Preservation Department – Item 1, LPC-26-11219

**98 Montague Street – Brooklyn Heights Historic District
Borough of Brooklyn**

98 Montague St Bossert Hotel Conversion NYC Landmarks Preservation Commission

Previous Proposed SW Axon

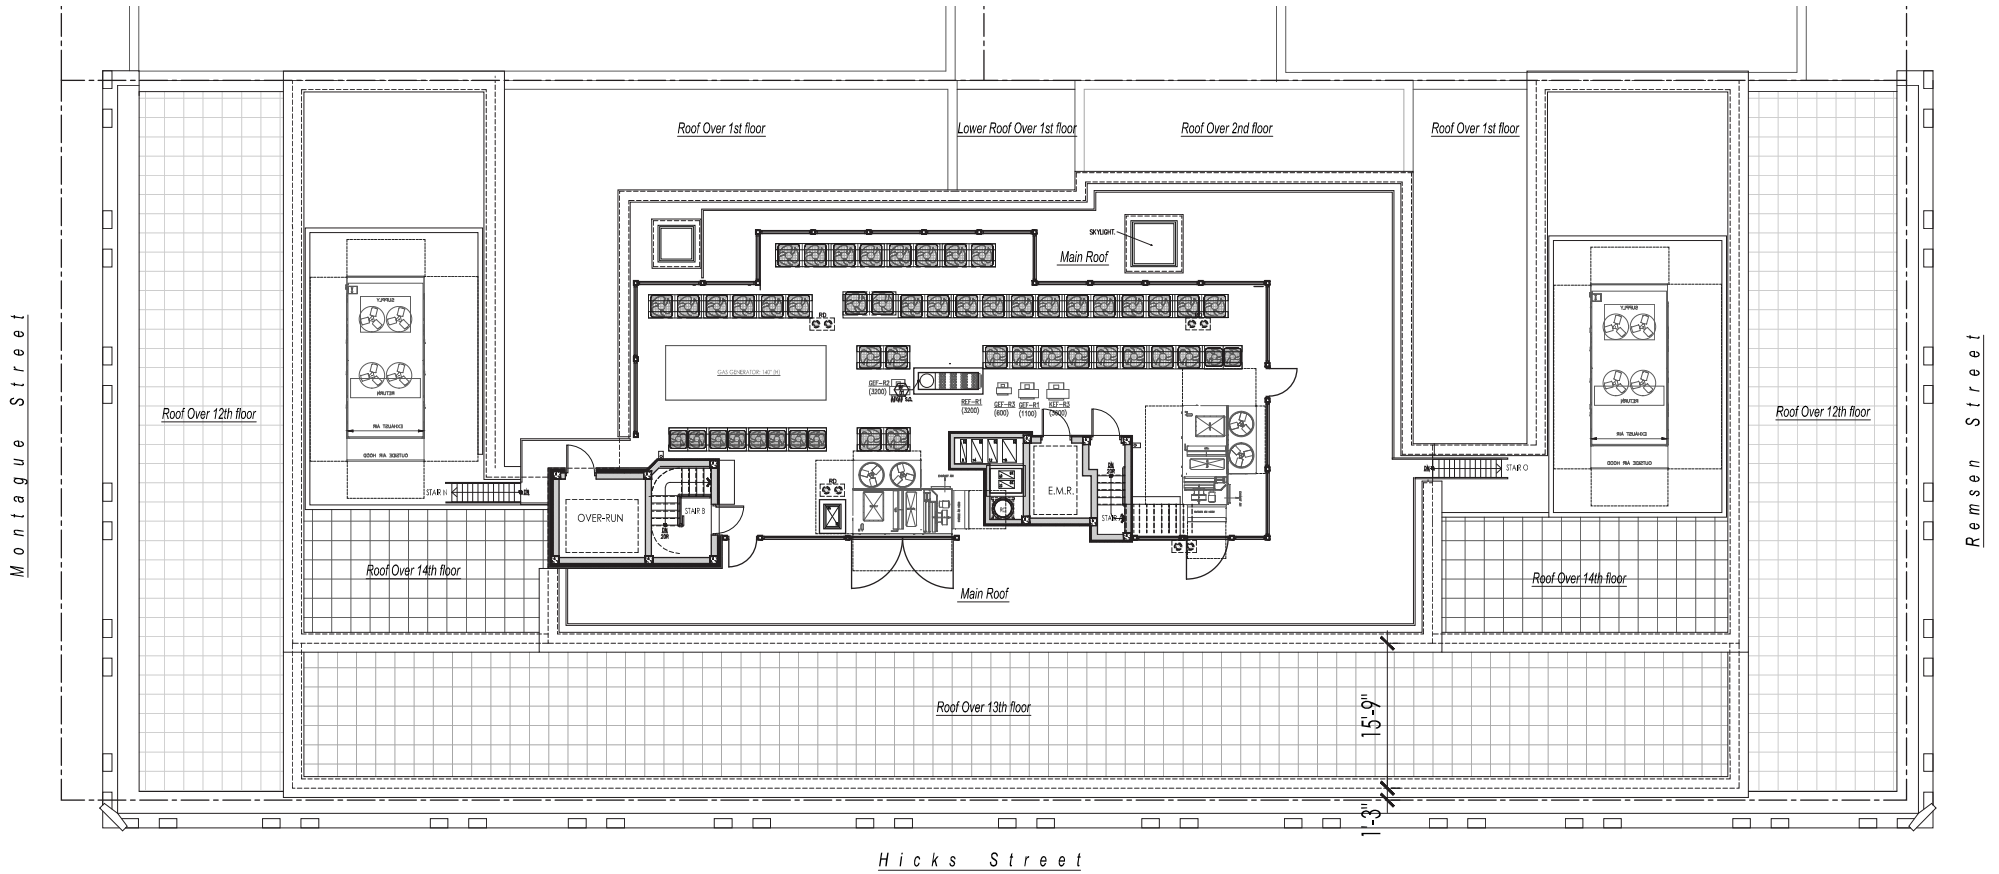
- 13th and 15th floors further set back
- Fenestration on all floors regularized and symmetrical, centered on the historic facade organization
- 13th floor cornice simplified; color of addition cladding darkened to enhance contrast with historic facade material
- Visible mechanical equipment at 14th floor relocated to reduce visibility and eliminate need for screening
- Stair and elevator bulkheads at 15th floor roof reduced in size and reconfigured to reduce visibility; mechanical screen height reduced
- Rear balconies changed to dark metal finish with metal picket rails to emphasize reading of light court
- Addition rear finish to match facade below, creating continuity with existing building
